Component GS-3-CAM, which is included in all GS-3-SMK-* variations.	Serial Numbers GS-C5-25797 and later*
	Control Number CC-11022022	Date November 2022
Technical Service Bulletin		
Subject: New camera sensor not compatible with software version 22.1 and earlier

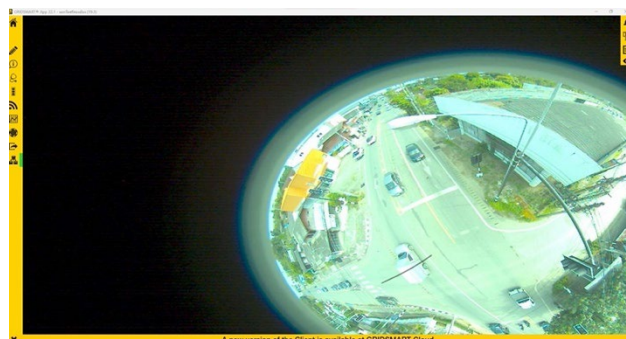
This Bulletin provides information and correction of an issue found with compatibility of a new camera sensor and older software versions. Beginning in August 2022 the GS-3-CAM Fisheye Bell Camera includes a new sensor that is not compatible with software versions 22.1 and earlier.

If you connect a camera with the new sensor to a Processor running older firmware the image produced will look similar to the following image –

The resolution for any GS2 system is to update to install the latest software version available from gridsmartcloud.com prior to replacing or publishing the new camera.
